LOCATION SLOPE STABILITY STUDY

BORDEN FARM SUBDIVISION

Further to your letter of May 24, 1973, we have reviewed the Foundation Report (No. 73704, dated April 1973) prepared by Golder Associates together with the information provided by you and submit the following comments.

REQUESTS FOR
SERVICES OF THE FOUNDATIONS OFFICEW.O. 73-11040(X)W.P. NO — nil — CONT. NO — SITE NO —LOCATION: PARCEL OF LAND WHICH IS BOUNDED ON THE EAST
BY HWY[#] 16 & ON THE NORTH & SOUTH BY BORDEN SIDE RD.
& NEPPAN CREEKSERVICES REQUESTED: REVIEW OF GOLDER'S REPORT ON SLOPE
STABILITY STUDY - PROP. BORDEN FARM SUBDIVISION
OTTAWAREQUESTED BY: MR. DELMAN OF MINISTRY OF NATURAL
RESOURCEDATE OF REQUEST: JUNE 6/73

FIGURE 3

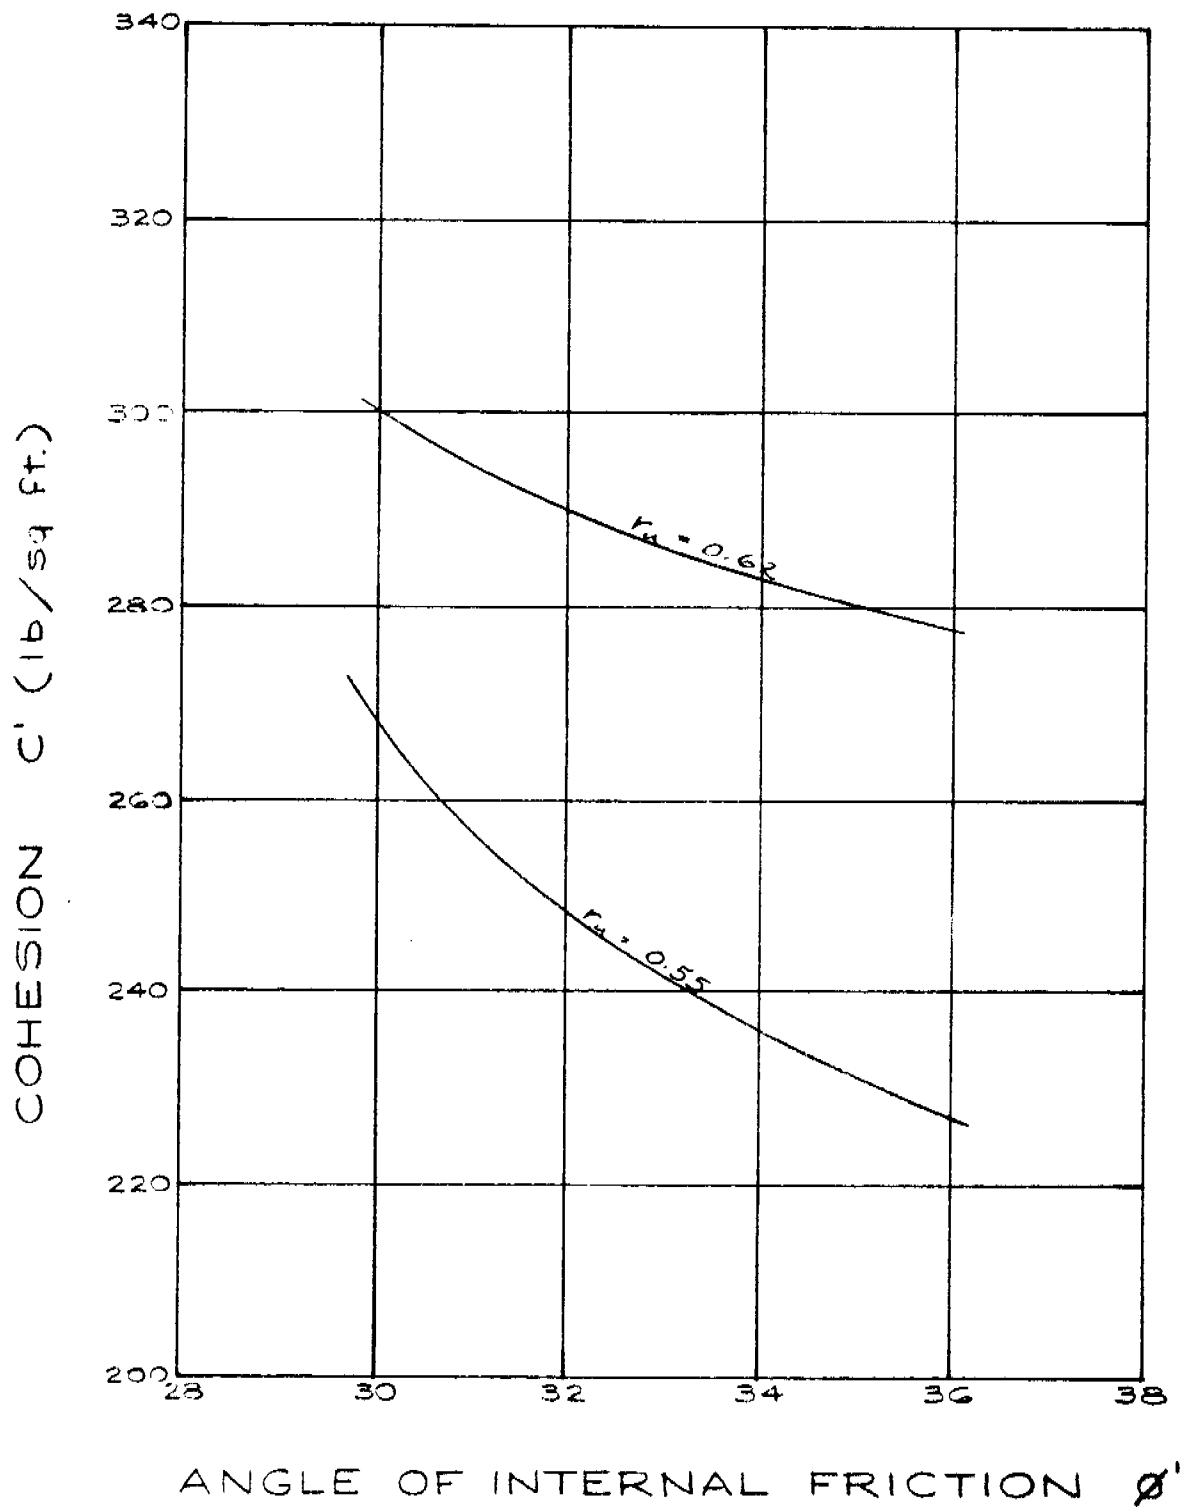
- ① Back calculations of a surficial slide
(MacDonald property April 1972) at west bank
of Rideau River (which is approx 400 ft east
of the subject site)

using $r_u = 0.55$ $r_u = 0.62$ $F_{\text{of } S.} = 1$, \therefore Result shown = Fig 3,
Result:
(1965 slide in
ex leaves out
by N.E.C.) $c' = 250$ psf $\phi' = 32^\circ$ \therefore seems to agree with

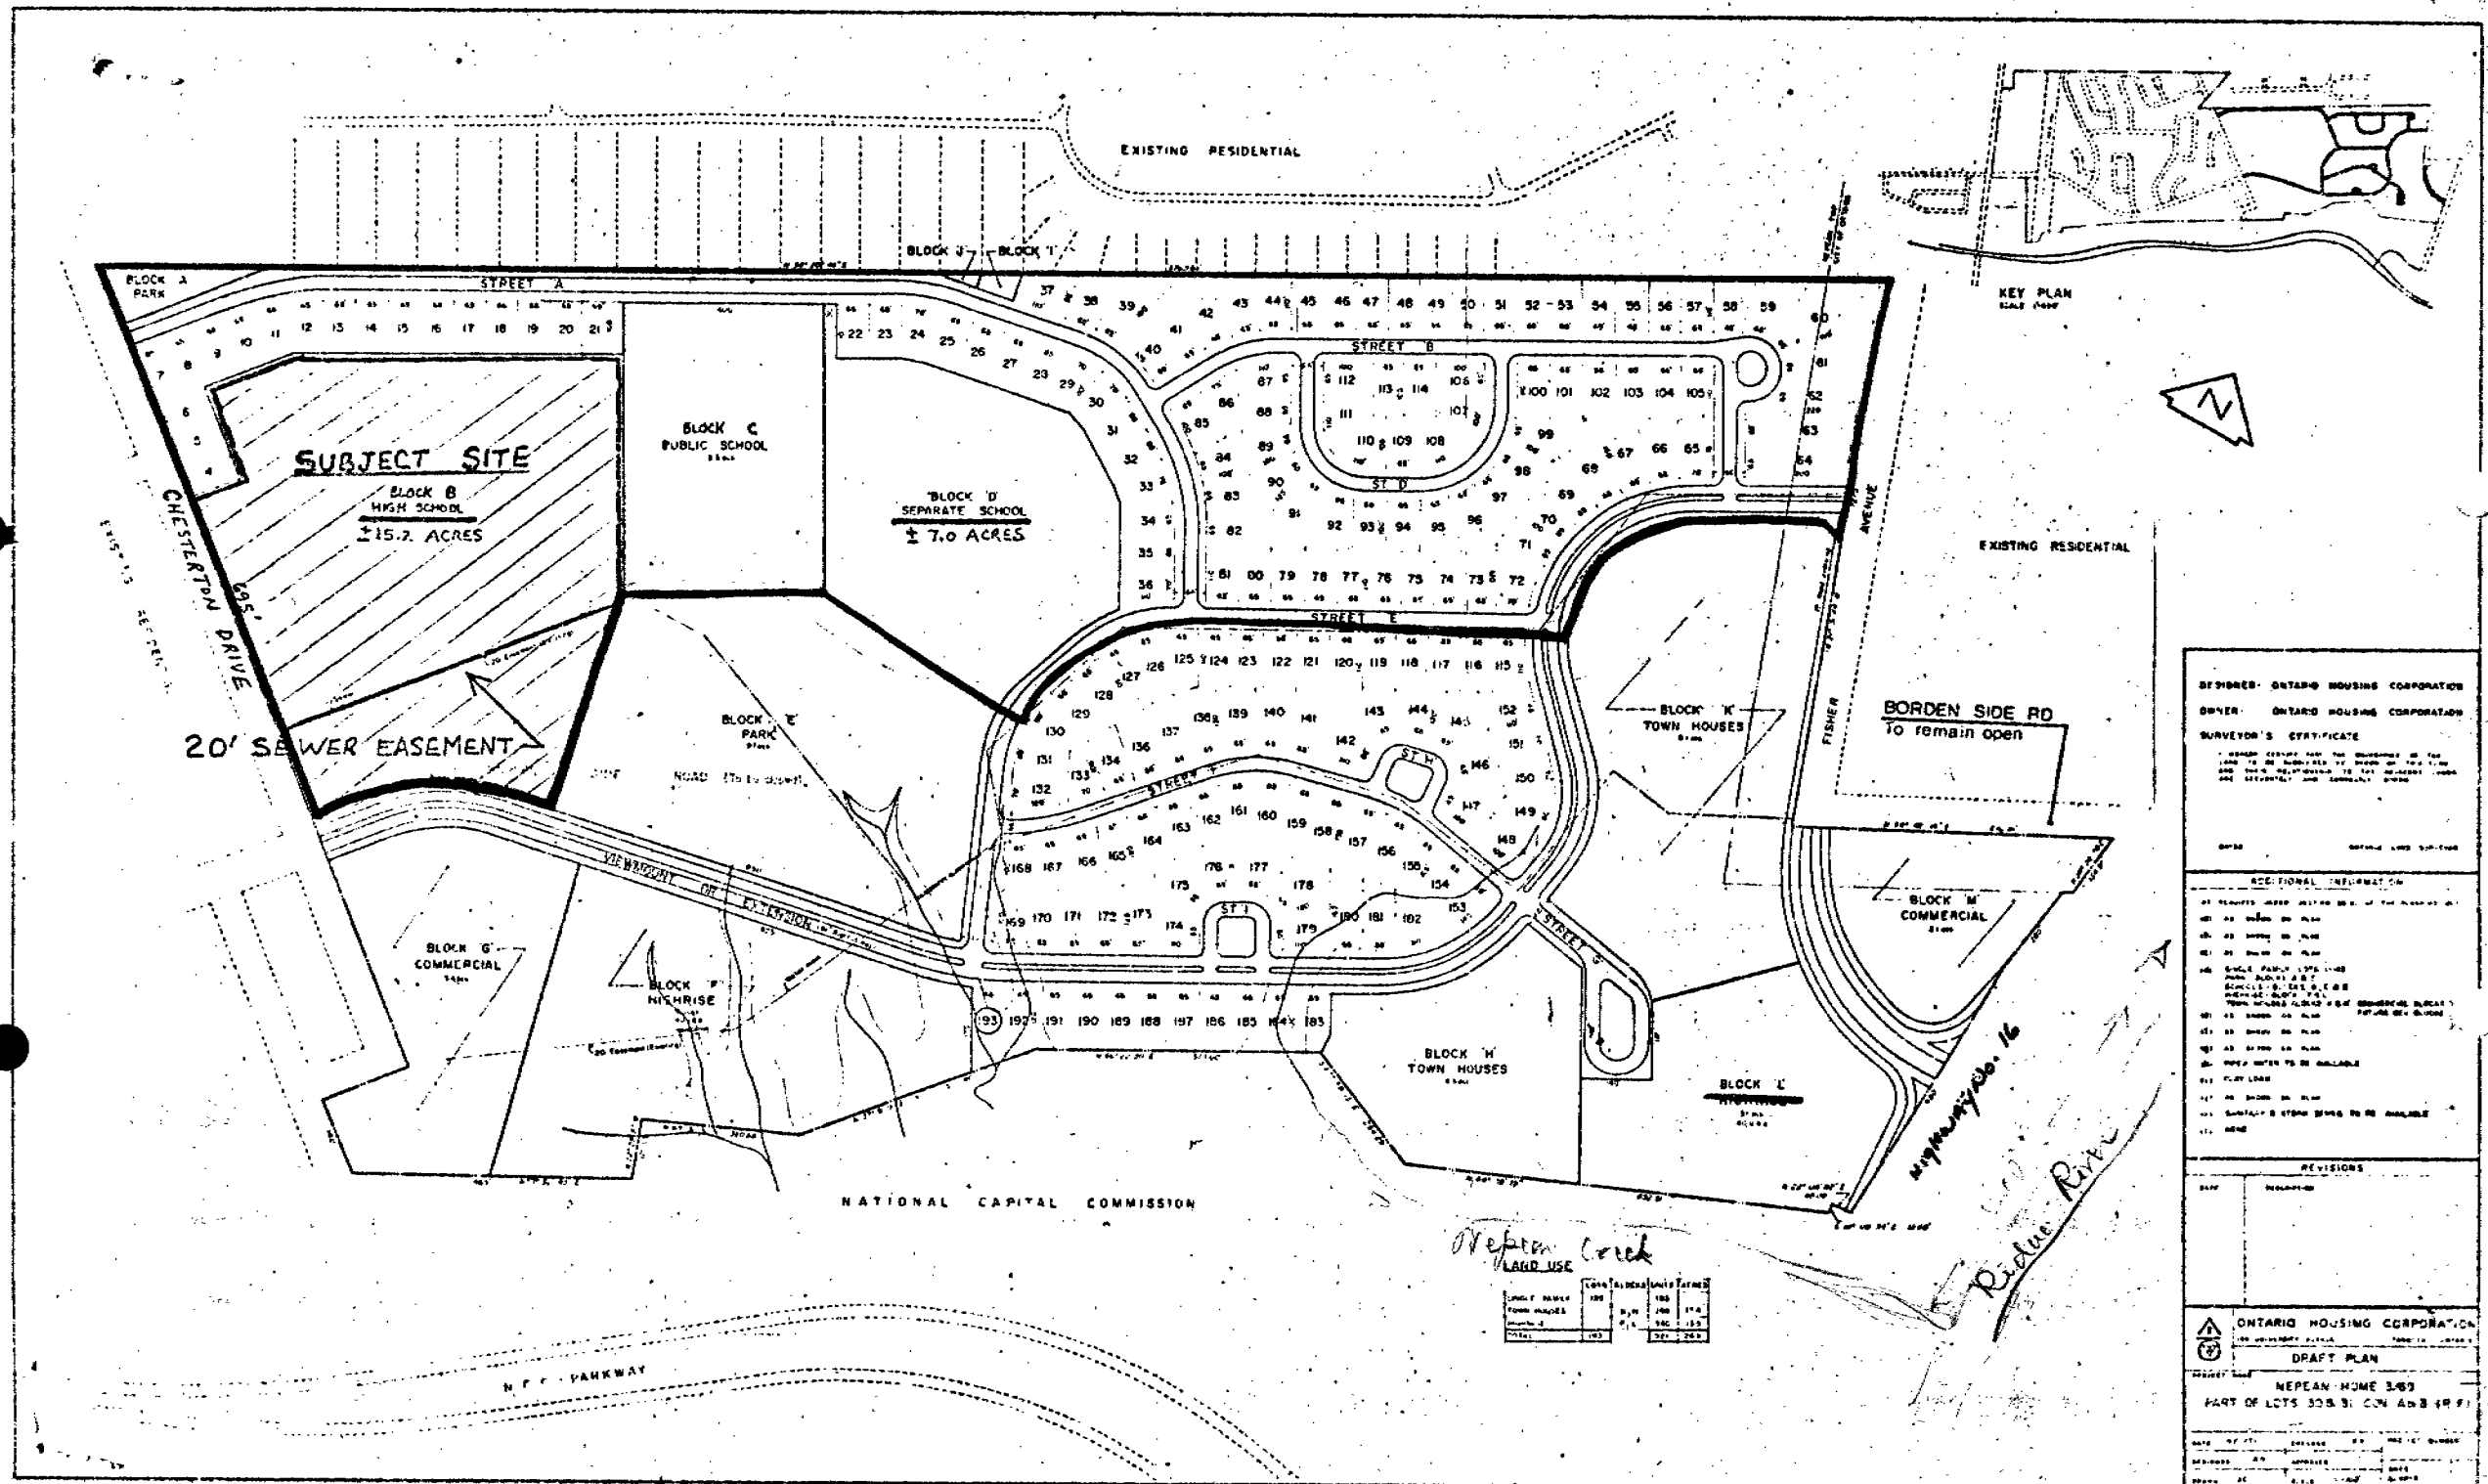
1. Is there a potential instability hazard at the present time on the site outlined in red on the copy of the plan attached to the inside cover of the Golders report or on the site immediately south of it?
2. Would the total development proposed add in any way to any instability hazard if the remedial works recommended for the Rideau River were not done?

The borings carried out by Golder Associates were confined to the areas (Blocks 'H', 'L' and 'M') which are outside the area outlined in red on the plan enclosed with your letter. It is, therefore, extremely difficult for us to comment on the two questions raised in your letter with regard to the possible instability hazards.

In any case, it is advisable to incorporate the remedial measures suggested by Golder Associates in their foundation report, since the future development in this area may likely increase the flow in the Nepean Creek.

SCHEDULE "A"

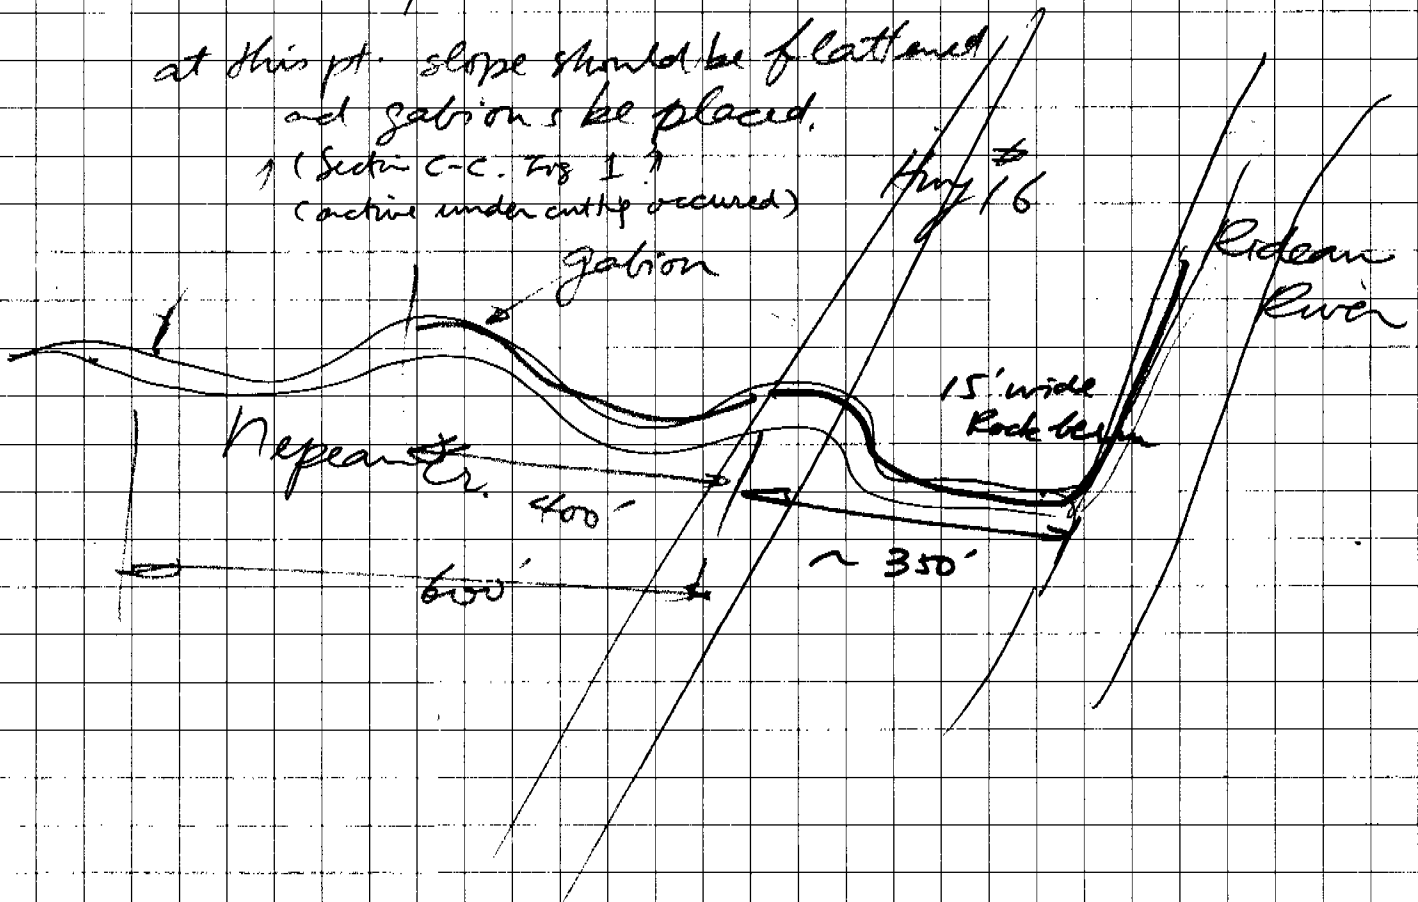
③ Recommendation:

at west Bank of Rideau River, 15-foot-wide rock berm installed at a level 2' above the H.W.L.,

also at north bank of Nepean Creek from Hwy 16 to Rideau River

at this pt. slope should be flattened and gabions be placed.

↑ (Section C-C. Fig 1)
(active under cutting occurred)
